Consumer Product Service
Manager of Technical Support
TECH TIP

number 6

MODEL: 810 Analog Disk Drive

Data Reliability on the 810 Analog Disk Drive

810 Analog Board location R218

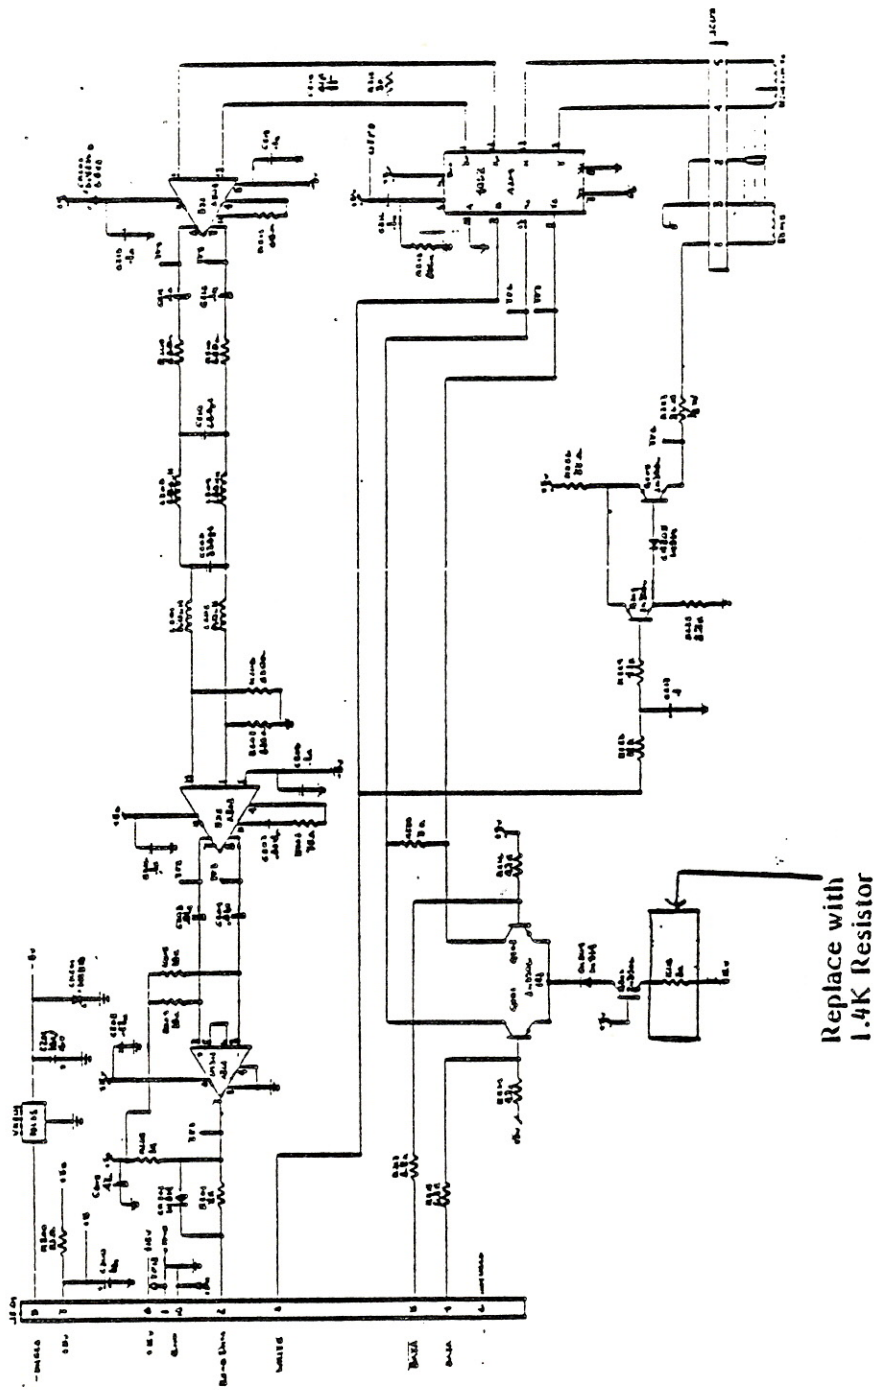
810 Analog Drives (those manufactured after August 1981) that exhibit diskette compatibility problems, and/or troubles in formatting new diskettes, should have the Write Current Resistor (R218) replaced with a 1.4K ohm resistor.

Part Removed:

2K ohm 1/4W 5% Resistor Atari P/N 14-5202

Replace With:

1.4K ohm 1/4W 2% Resistor Atari P/N 14-2142
